Meeting Date:  
March 9, 2026

Request:  
Conditional Use and Site Plan request for Western Reserve Academy for an addition to the Wang Innovation Center.

| Hudson Planning Commission | CONDITIONAL USE/SITE PLAN REVIEW –<br>WRA – WANG INNOVATION CENTER |
| Case No. 2026-72           | March 9, 2026                                                      |

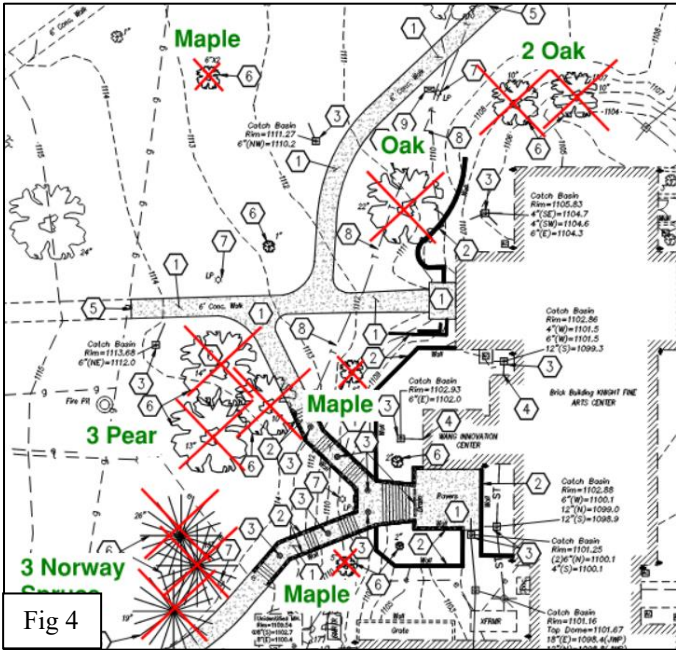
Staff Comment: Staff recommends sidewalks be installed along N Oviatt between the adjacent curb cuts to meet this requirement (see Figure 3).

1. Revise the civil drawings to incorporate stormwater improvements to the northern pond in order to be compliant with the requirements for retention/detention as stipulated in Section 1207.07.
2. Revise the civil drawings to include a sidewalk extension as depicted in Figure 3 of the staff report in order to be compliant with pedestrian pathways and linkages requirements of Section 1205.04(d)(11).
3. Further study tree and vegetation protection per the analysis on pages 7 and 8.

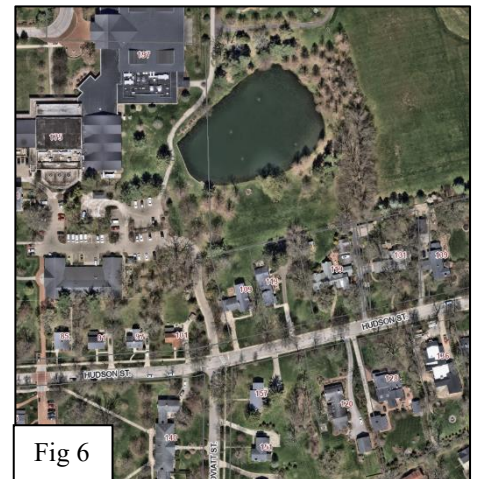
The Assistant City Engineer has reviewed and suggested modifying the pond to the north (see Figure 6) to fulfill the LDC requirement of stormwater retention/detention for new major development proposals. The Assistant City Engineer recommends the pond be enlarged and the control structure be modified to reduce storm flow. This pond is located in the same drainage basin as the proposed building addition and would provide benefit for heavier storms.

Staff recommends the applicant design these modifications and submit for review as part of this application.
